141156/FO/2024

Stopford Building West elevation glazed in louvres (A)

10 January 2025

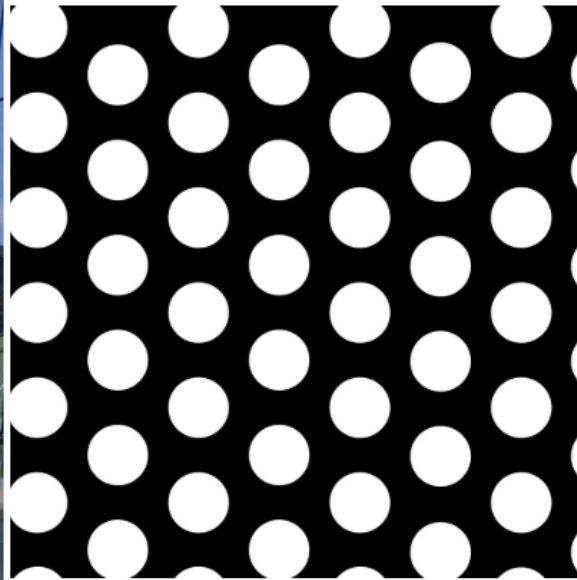
With regards to utilising 4 windows, existing ductwork in the ceiling void prohibits the new ventilation making its way to the remaining 2 windows in the room.

However, following the ideology set at National Graphene Institute we can change the glass in 2 windows to high gloss black perforated panels, to mimic the reflectance of glass. At this is a rainscreen approach, a louvre will be required behind the panel to provide weatherproofing, though this will not be seen.

The product proposed is FH Brundle perforated metal panel with a hole diameter of 5mm and free area of 63%.

This build up has been checked by our Mechanical designer who has reviewed a variety of different free area panels, and concluded this will provide the correct ventilation for the occupancy.
